REMARK**Status of Claims**

Drawing Changes

FIG. 1

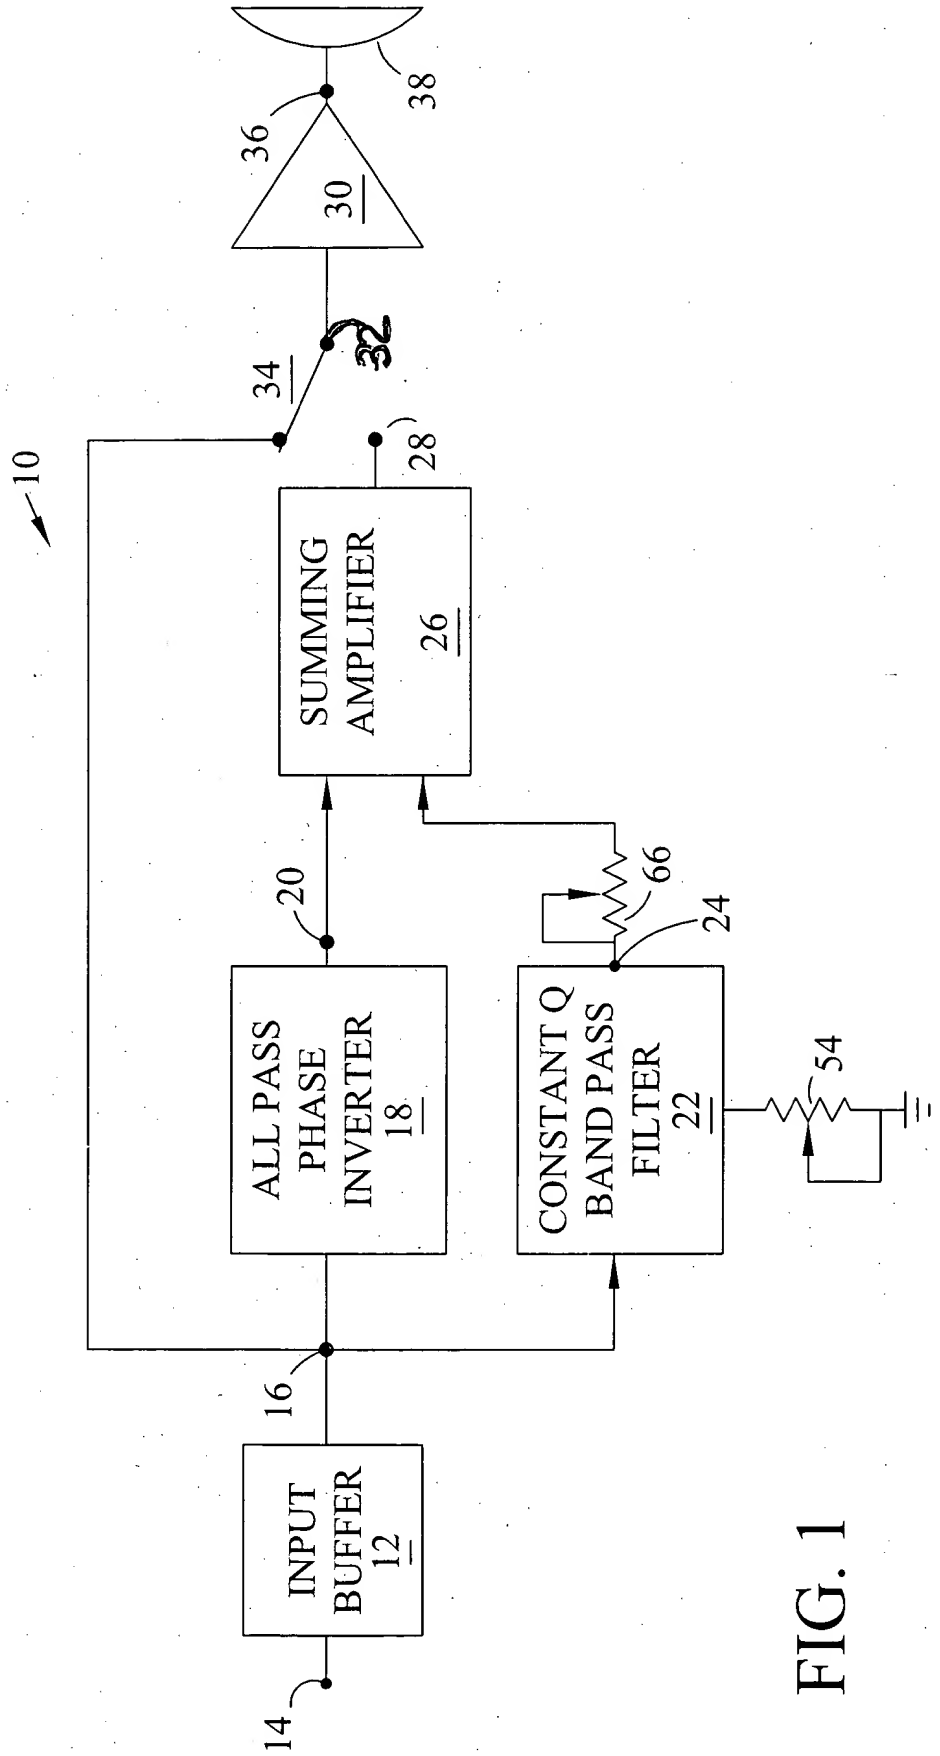
Figure 1 is amended to add reference number 32 to identify the transfer contact of switch 34. Reference number 32 is used in the specification at page 5, line 17.

FIG. 2

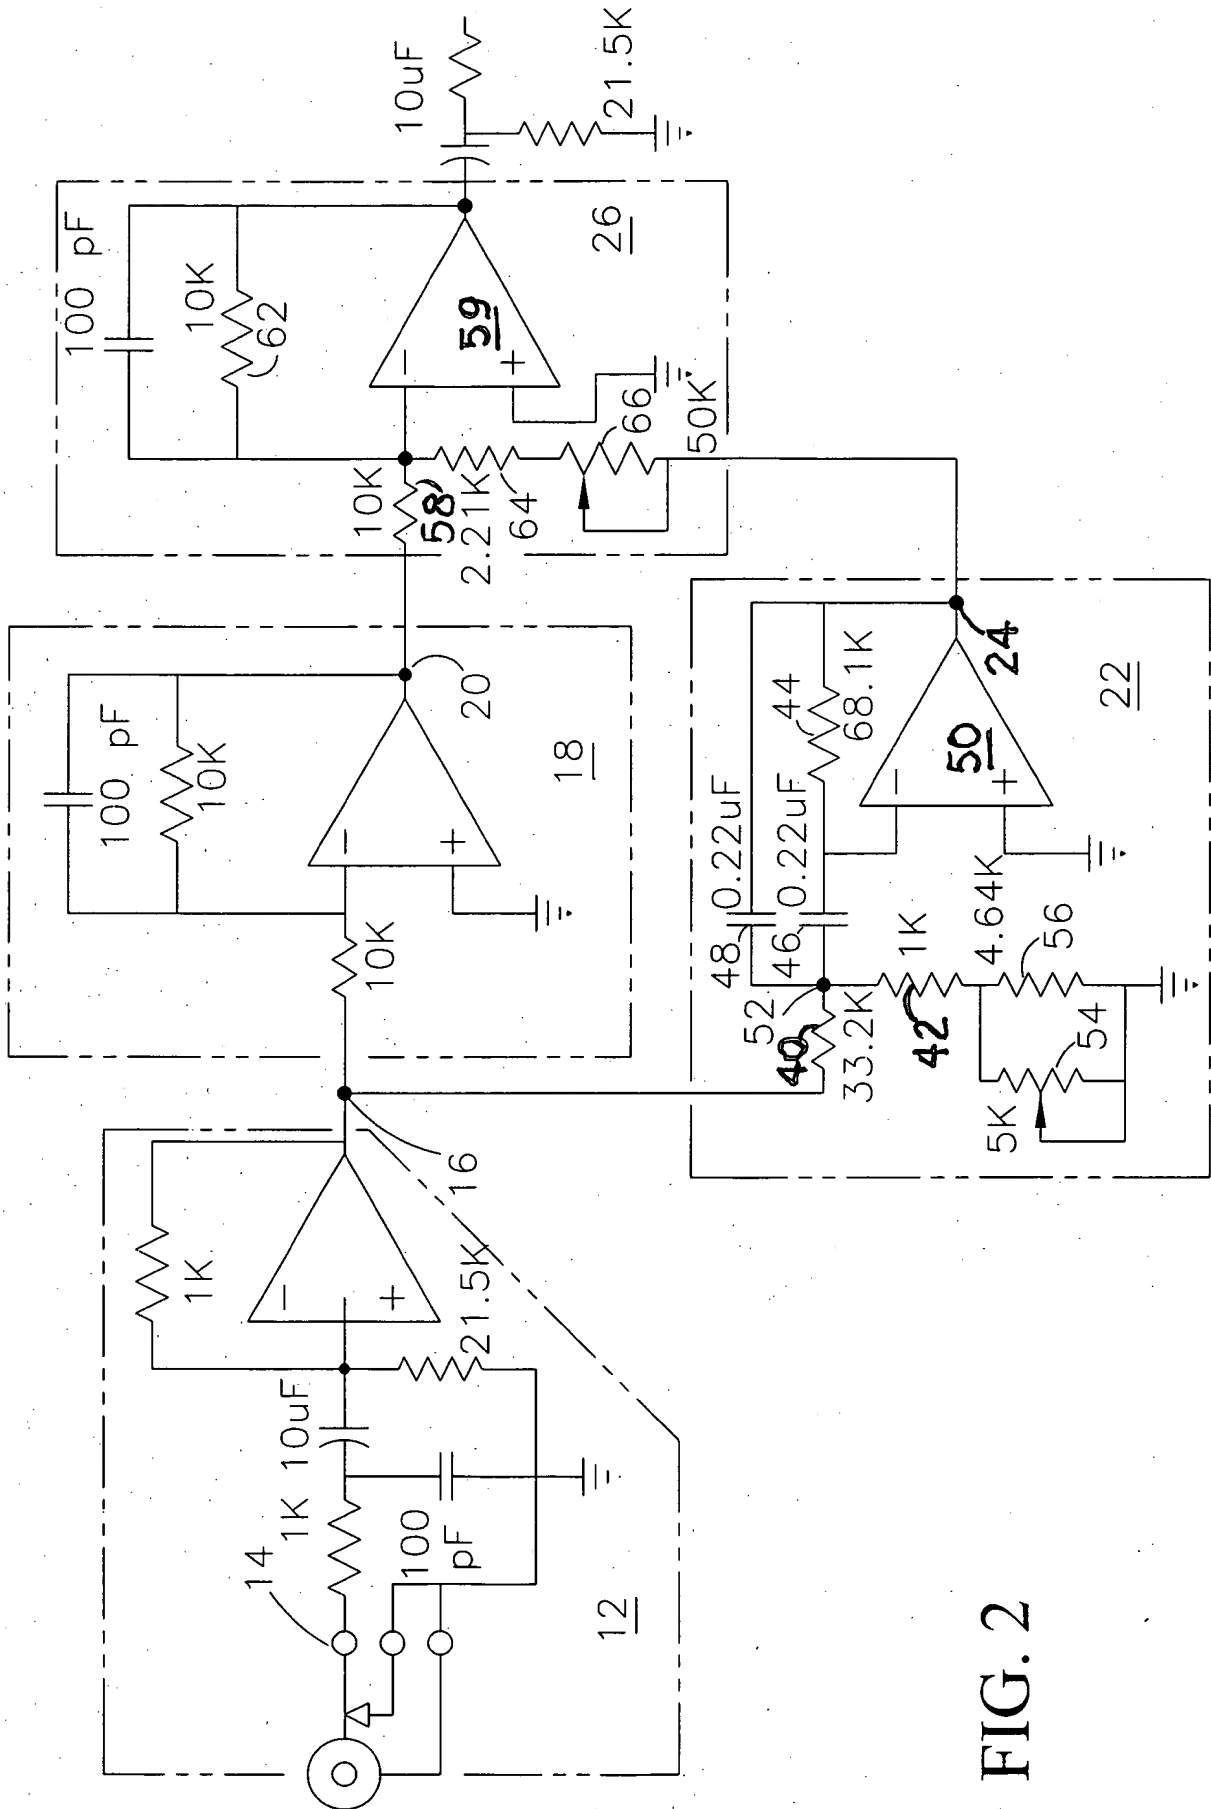
Figure 2 is amended to move reference number 20 slightly to the left and to add reference number 24 to the output of the Bandpass filter 22. Reference number 58 is added to top input resistor of integrator 26. Reference number 59 is added to the operational amplifier in integrator 26. Reference number 50 is added to the operational amplifier in the Bandpass filter in phantom block 22. Reference numbers 40 and 42 are added to identify resistors in phantom block 22.

FIG. 3

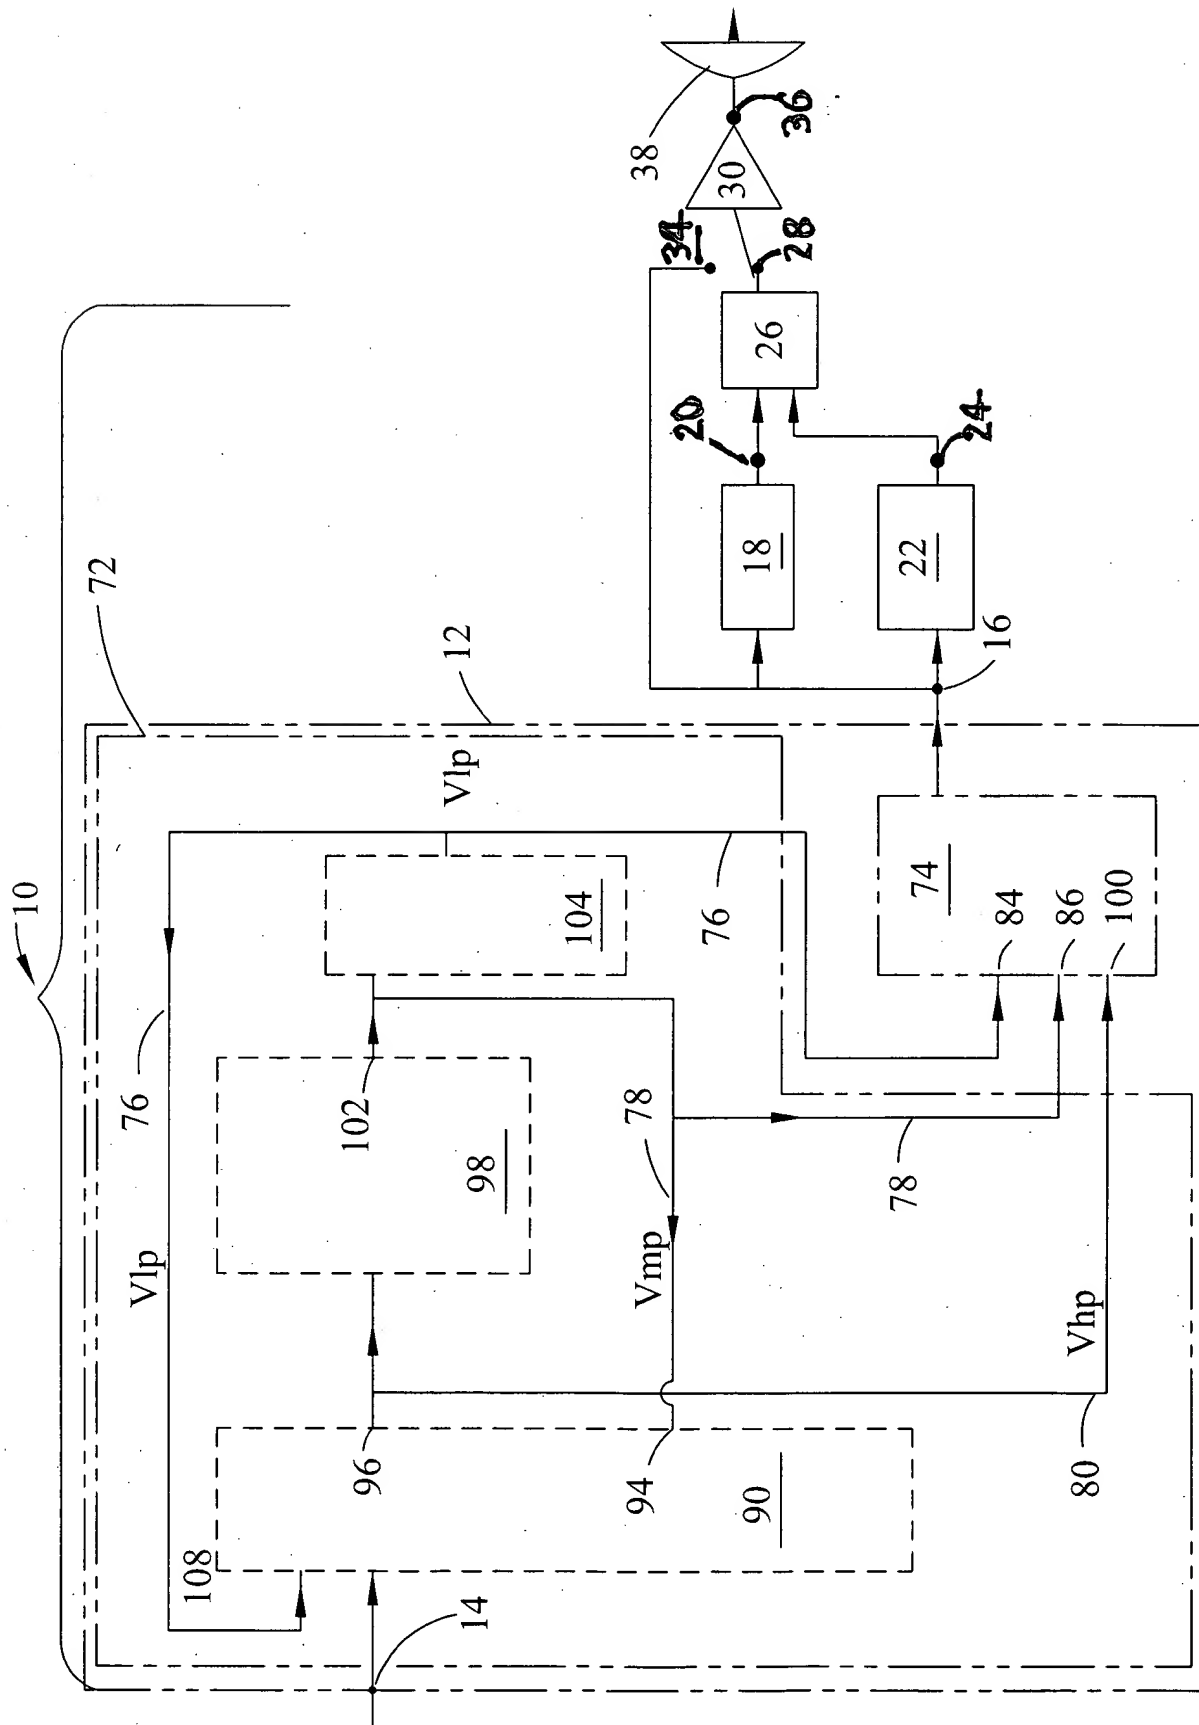
Figure 3 is amended to add reference number 20 to the output of block 18 and to add reference number 24 to the output of block 22. Reference number 28 is added to the output of block 26. Reference number 36 is added to the output of power amplifier 30. Reference number 34 is added above switch 34. Original Figure 1 shows the added reference numbers at the amended locations.

FIG. 4

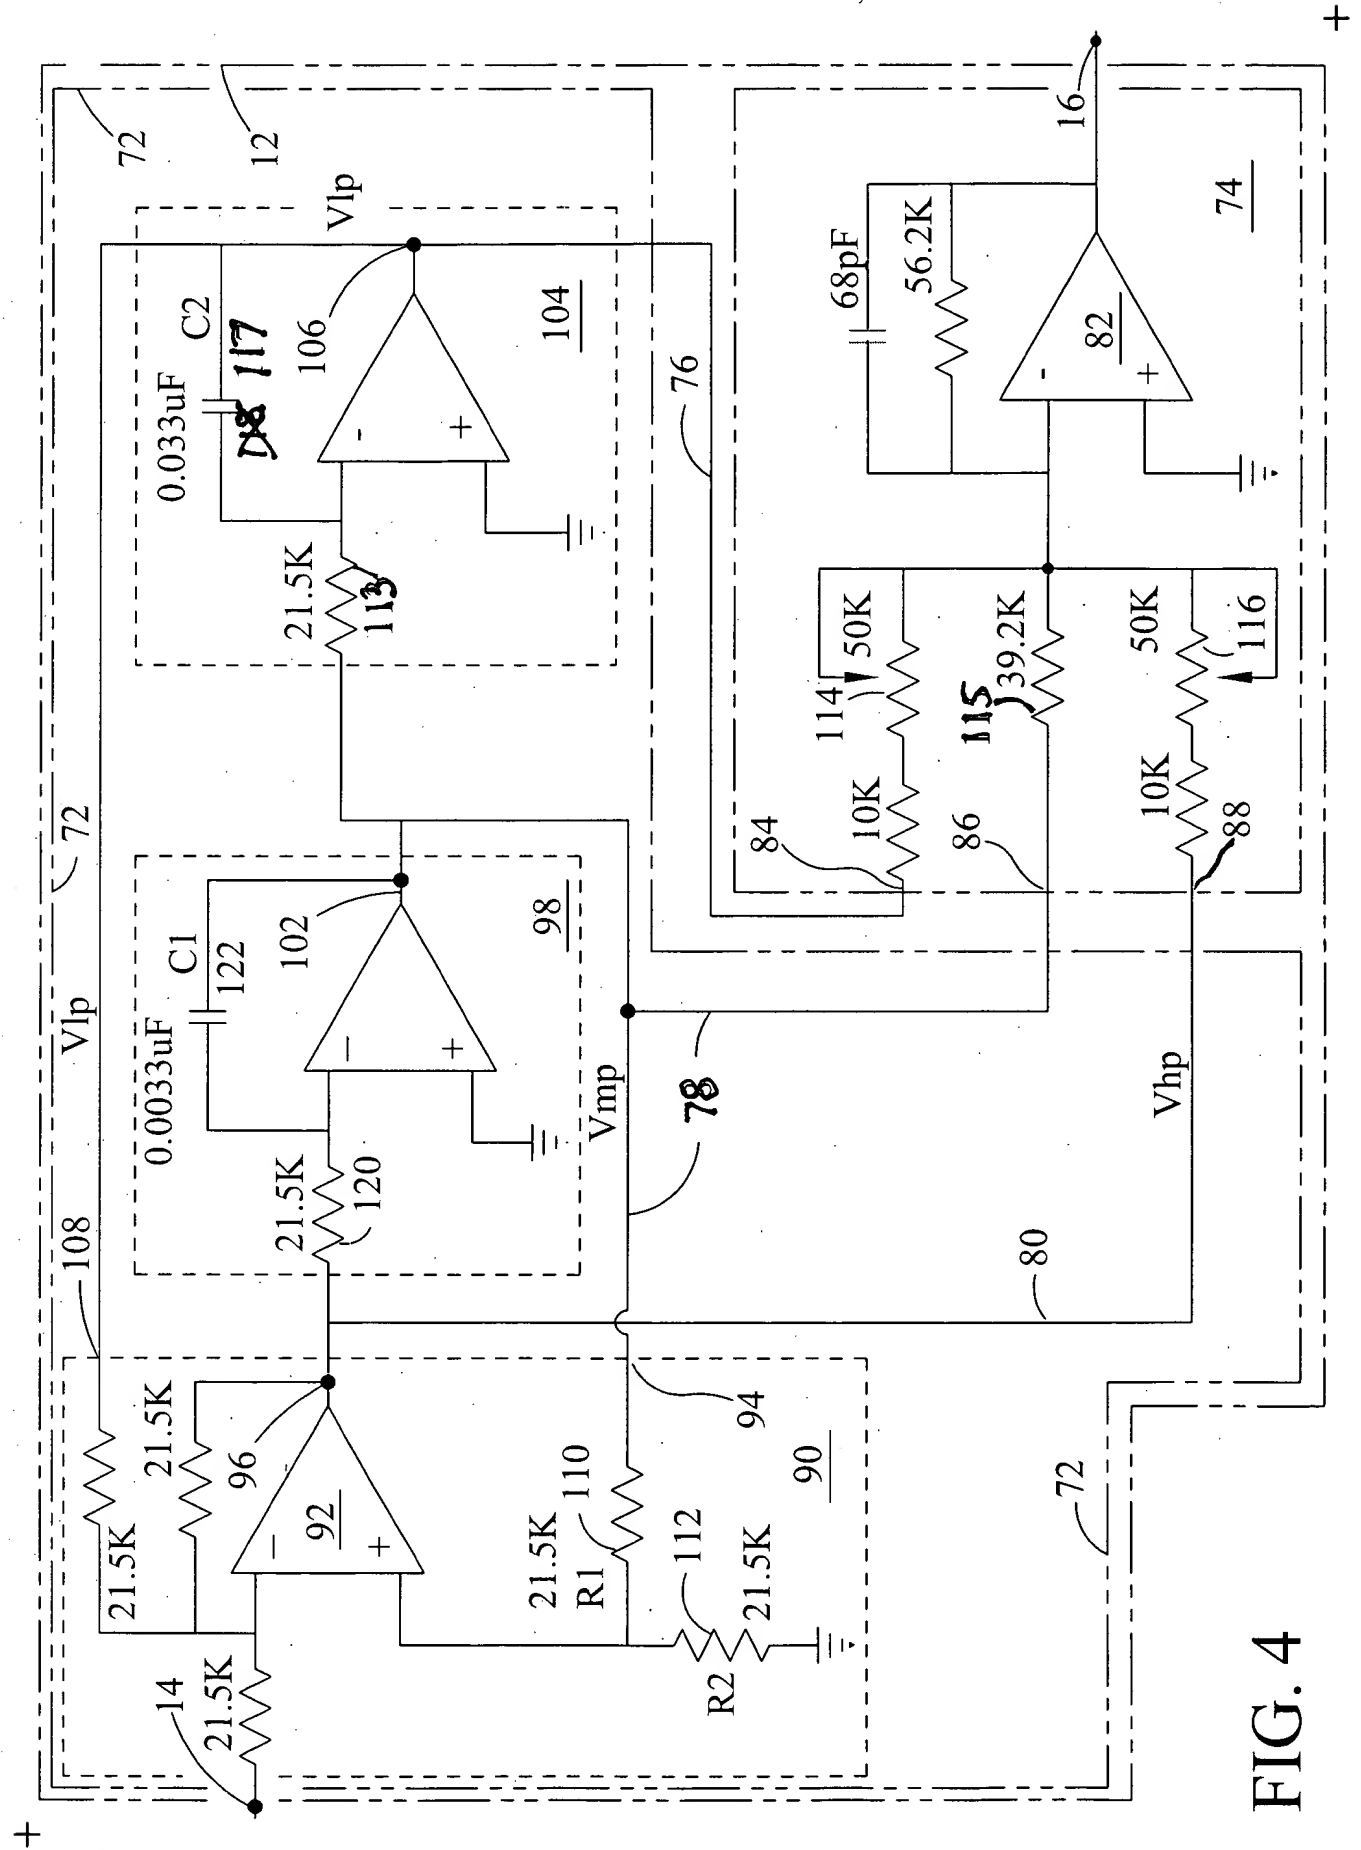
Figure 4 is amended to change reference number 70 to be 78 to be consistent with Figure 3. Reference number 115 is added above the mid-range input to the Summer 74.
